DELEGATED DECISIONS BY CABINET MEMBER FOR TRANSPORT MANAGEMENT

5 SEPTEMBER 2024

BOTLEY ROAD, OXFORD – PROPOSED CYCLE LANE AMENDMENTS 2024

Report by Director of Environment and Highways

BOTLEY ROAD PROPOSED ROAD MARKINGS SERIES 1200

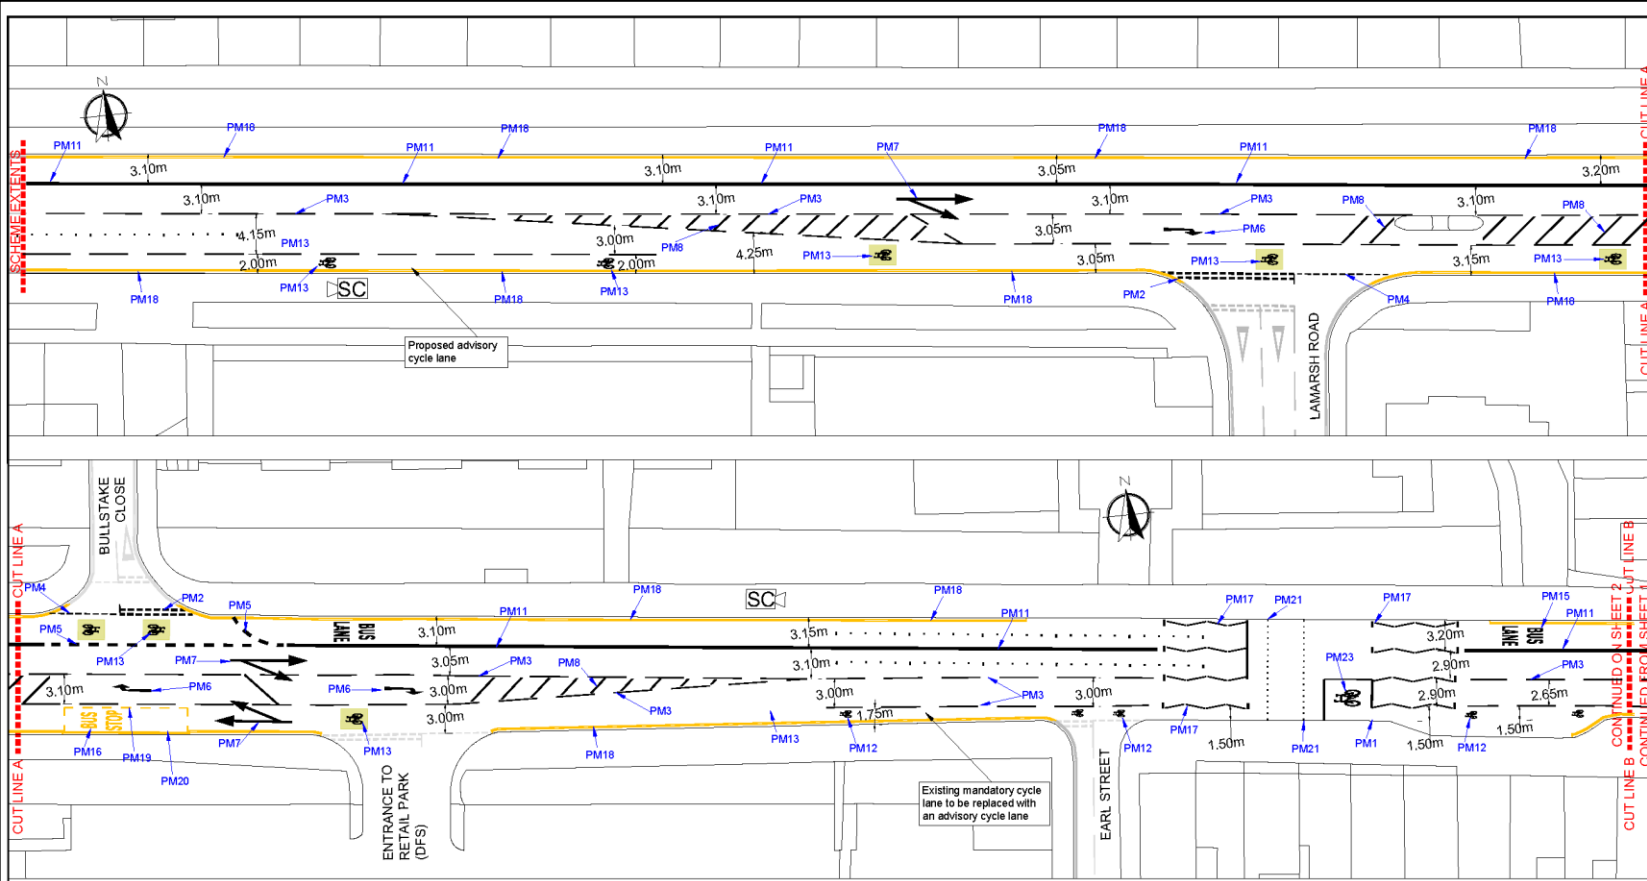
<p>(66) County Cllr, (Jericho & Osney division)</p>	<p>Partially support – Is there evidence to show that wider advisory cycle lanes are safer than narrow mandatory ones? It seems counter-intuitive. Will the road surface be improved? The poor surface and potholes and badly engineered drain covers are dangerous for cyclists. Extending the 20mph speed limit promised long ago and enforcing it would be a game-changer.</p>
<p>(3) Local group/organisation, (Oxfordshire Cycling Network)</p>	<p>Support – This response is on behalf of the Oxfordshire Cycling Network, which represents over 30 cycling groups and campaigners across the county, and campaigns for better cycling infrastructure in a county where 250,000 adults cycled in 2023, but 600,000 could. Overall, we support the changes proposed in this consultation. We have some suggestions for enhancements.</p> <ul style="list-style-type: none"> • We support the move from very narrow mandatory lanes to 1.5m and wider lanes, because this provides additional space for cyclists. This is important for comfort and safety. We do not believe that most drivers treat advisory and mandatory cycle lanes differently. However, see note on parking enforcement below. • We note that the national guidance for cycle lanes is for 2.0m minimum width in low volume situations, and 1.5m only at short width restrictions, thus every opportunity should be taken to make the lanes as wide as possible. The resulting carriageway reductions will also provide traffic calming.

<p>We agree with the widening of the cycle lanes to 1.5m advisory lanes, though in places the lanes could be made 2m wide and therefore mandatory. In that situation it would be good to have wand orcas which will increase the perception of safety. The widening of the cycle lanes and narrowing of the central carriageway may help act to calm traffic.</p> <p>In normal times (when the railway bridge is not causing road closure) this is a busy road. Although not part of this consultation it is essential to make the road safer and we ask for 20mph for the whole length of Botley Rd. As Vision Zero should be a consideration for every highways change, we think that this change will be far more effective in attracting more cycling than the relining changes you are proposing in this consultation. Even where there is off-carriageway cycling provision, there are still people doing cycle right turns onto and off Botley Rd, and drivers turning off Botley Rd (who would be doing so more slowly if the main road were 20mph, and pedestrians crossing it. So this is a prime candidate for 20mph speed limits.</p>

(19) Local resident, (Oxford, Botley Road)	Object – I cycle along here with my 8 year old. The proposal around the bus stop area outside the new DFS is ridiculously dangerous. It expects cyclists to navigate around buses, potentially using a central lane (the RH turn into Bulstake) so effectively being in the middle of the road, just before trying to cross the very dangerous junction that is Lamarsh road (which is already very dangerous because it is very wide and lulls drivers into a false sense of security). It looks like it has been designed by someone who has designed it by using a computer model of the road and possibly looking at google maps. Whoever designs this needs to try using the road by bike and on foot themselves, and try pausing and watching how the traffic moves around the Lamarsh junction for 20 minutes and what happens when there's a bus waiting at the bus stop.

<p>(71) As part of a group/organisation, (Oxford, Stratfield Rd)</p>	<p>Partially support – This looks mostly reasonable if the constraints are that we can't touch the right-turn lanes (or the bus lane).</p> <p>In general we believe wider advisory cycle lanes work better than narrow mandatory ones. However there are two major concerns with this.</p> <p>The first is that this kind of layout involves regular sharing of space. Wider vehicles such as buses need to enter the cycle lanes and people driving cars want to (to avoid being so close to motor vehicles going the other way). And people cycling need to leave the cycle lanes to overtake people cycling slower.</p> <p>These events are more frequent on higher speeds roads, because people driving at higher speeds are less willing to be close to motor vehicles going the other way, as well as more dangerous. So we believe this layout should only be used on 20mph roads (or, if on higher speed roads, only with low volumes of traffic, much lower than Botley Rd). So this layout should be approved only if it is expected that this stretch of Botley Rd will become 20mph sooner rather than later. (With "sooner" perhaps meaning "less than half-way to the next relining".)</p> <p>The second concern is that advisory cycle lanes may encourage illegal parking.</p> <p>Finally, two suggestions on specific details.</p> <p>There are a few places where the cycle lanes could perhaps be made wider and the carriageway narrower, keeping in mind that the (LTN 1/20) recommended width for cycle lanes is 2 metres, with 1.5m as a bare minimum. For example, the eastbound bus lane widens to 3.2m between cut line A and cut line B? Can we shift 0.1m to the cycle lane on the other side?</p> <p>Can the centre lines be removed between Earl St and the Waitrose Delivery Access, and between Binsey Lane and Helen Rd? This would be consistent with layouts elsewhere. The narrowest central two-way lane here would be about 5.8m in the first stretch and 5.3m in the second.</p>

16. Whilst the proposed advisory cycle lanes are themselves at the minimum 1.5m standard highlighted in LTN 1/20, this is considered an appropriate balance where vehicle lanes are also of a reduced width but sufficient for the overwhelming majority of vehicles (with the exception of buses and HGV's) to not need to straddle an advisory cycle lane.

20. A suggestion was made that centre line markings be removed between both Earl St and the Waitrose Delivery Access and between Binsey Lane and Helen Rd. Officers agree and consider this would be consistent with treatment where wide advisory cycle lanes have been installed on other key routes in Oxford

21. A small number of responses noted that there were inconsistencies in lane widths and/or suggested localised amendments. These will be carefully reviewed and subject to some localised/ minor amends including to ensure consistency and where possible sufficient running lane widths for traffic lanes where buses are operating.

Drawing Number: 5229823 - ATK - HMK - XX - DR - CH - 001202

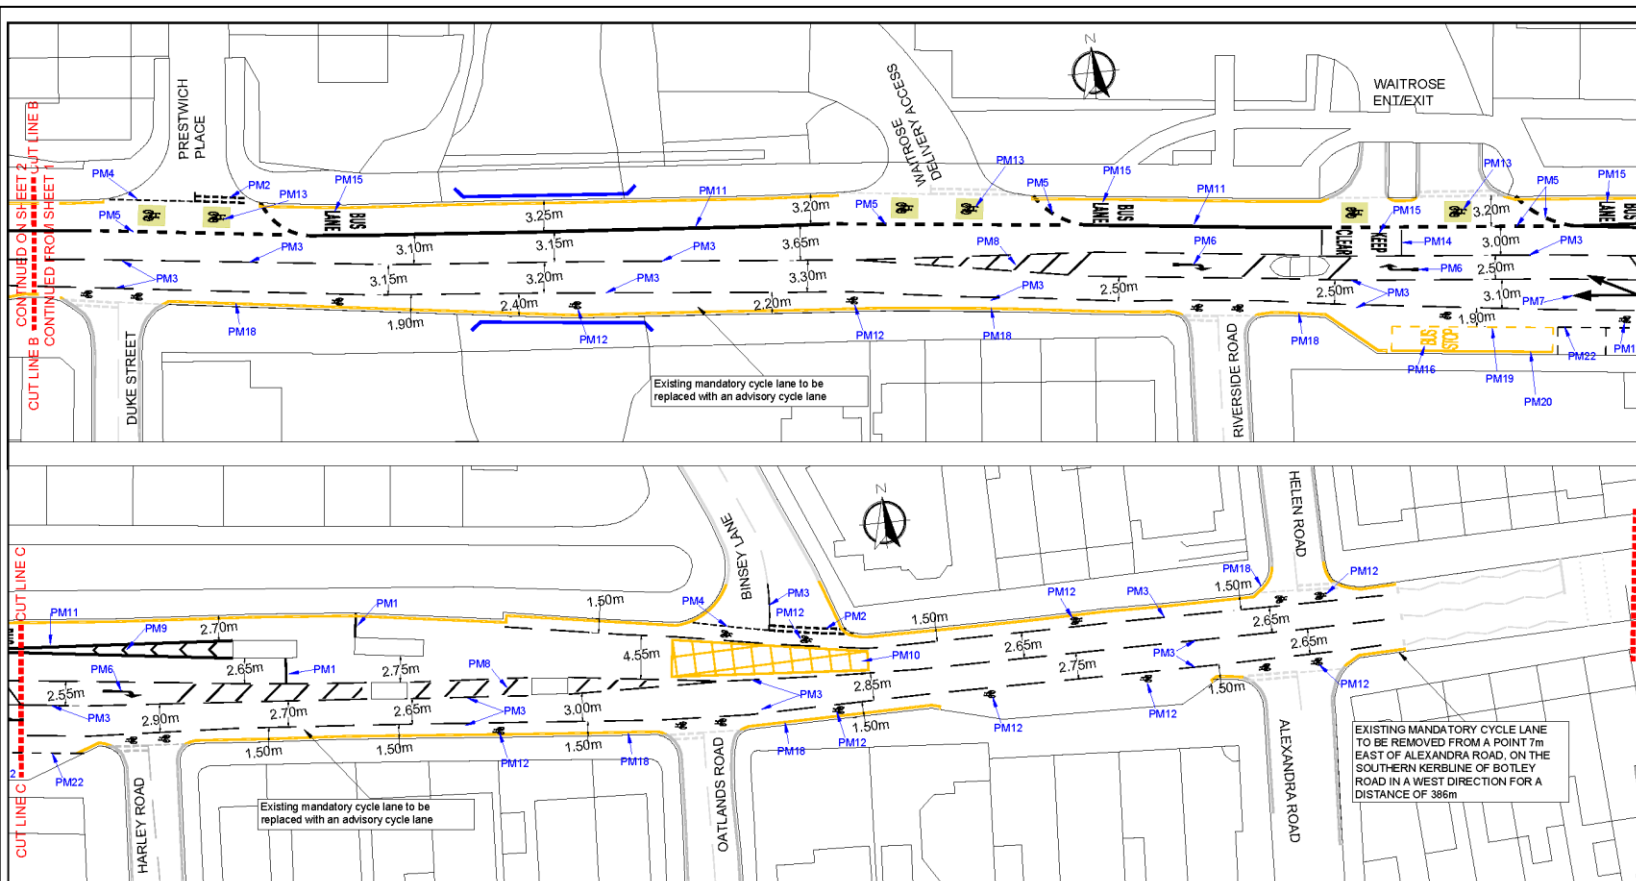
<p>(58) Local resident, (Didcot, Plym Drive)</p>	<p>Partially support – Partially support.</p> <p>I would fully support removing the central hatching and right turn lanes and widening the mandatory cyclelane. A dotted cyclelane is akin to no cyclelane.</p>
<p>(59) Local resident, (Oxford, Botley Road)</p>	<p>Partially support – Its a good idea but promotes tandem cycling side by side, impacting motor traffic flow. A dedicated kerbed cycle lane way would be a better option. Also an advisory lane, will be adopted as mandatory lane by cyclists.</p>
<p>(60) Local resident, (Oxford, Botley Road)</p>	<p>Partially support – The cycle lanes on Botley road in general are quite a mess and so I do support any changes that simplify their interpretation and use. In particular, cars at intersections that creep into pedestrian/cycle crossings. It appears that these modifications would alter this by making the cycle lane in the road and therefore bicycles considered as first class road users (as they should be). However, it is unclear to me, as a lay person, what precisely the planning documents actually translate to in practical terms. For instance, it is quite hard to discern if the pavement space where the cycle lanes are currently located will be given over to pedestrians or allowed for the road itself to be widened. I think this consultation needs a high level document to accompany it so that regular citizens can get an accurate idea of the proposed changes. Satellite images with informal mark up might be helpful in this instance.</p>

<p>(69) Local resident, (Oxford, Southfield Park)</p>	<p>Partially support – The available width varies along Botley Road. Please retain the mandatory cycle lane at all points where there is sufficient width, with protective wands (as in the short stretch of Iffley Road opposite James Street) on the *outside* of the lane markings.</p>
<p>(70) Local resident, (Oxford, Spring Lane)</p>	<p>Partially support – Your documented reasons include no rationale on *why* the proposed change will be any safer. It appears to me that widening the cycle lane might be slightly safer if there is sufficient room on the road for drivers to actually respect the advisory cycle lane, but there is no legal requirement for them to do so.</p> <p>Additionally, once Botley road (eventually) reopens to city centre traffic after the bridge/station works are complete, will an advisory lane not simply get blocked by queued traffic at peak times, leading to greater risk to cyclists?</p> <p>Research shows that both on-road mandatory and on-road advisory cycle lanes can actually increase the risk to cyclists by encouraging close passes. Neither solution seems adequate to me, nor much better than no road markings at all. The removal of the mandatory status means no legal requirement for drivers to respect the cycle lane at all. (There are places along this cycle lane that have enough pathway to allow space for a segregated cycle track, which would be my preference over both the current and proposed solutions.)</p> <p>Perhaps a wider lane might be safer to some small degree -- it is a shame you provide no rationale or evidence to support this.</p>
